**PERIODIC DAM SAFETY INSPECTION REPORT**

**HARTLAND HOMES NORTH DAM**

**IDENTIFICATION NUMBER NE02516**

**REPORT: 07/05/2016**

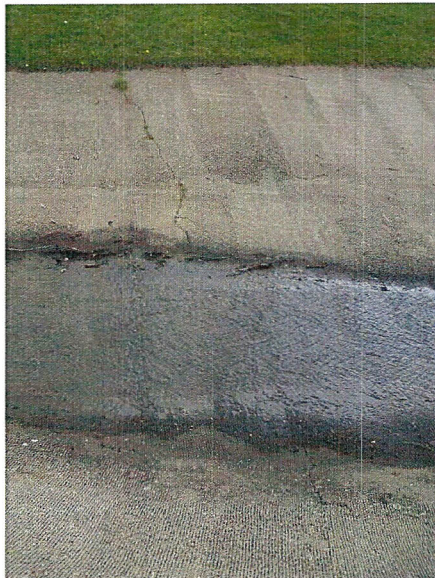
Looking upstream  
at the downstream  
slope of the dam  
embankment.

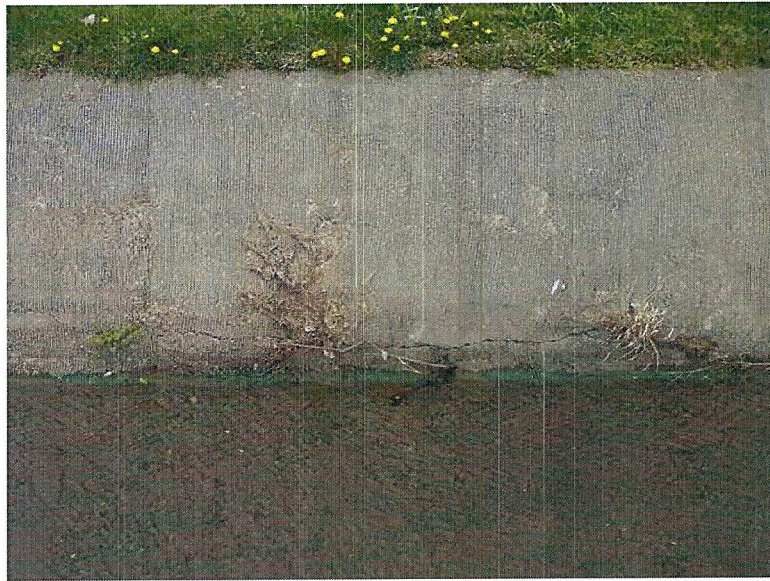
1. A transverse crack across the spillway about 20 feet downstream of the spillway inlet.
2. A longitudinal crack along the right side slope of the spillway in the middle portion of the spillway.

An unsealed transverse crack running across the spillway about 20 feet downstream of the spillway inlet.

The cracks should be sealed with a polyurethane caulk to ensure that:

1. Freeze-thaw damage does not occur in the affected area(s).
2. The steel reinforcement within the concrete is not exposed to moisture. If the steel reinforcement is exposed to moisture, it will corrode and swell, which will break up the surrounding concrete.
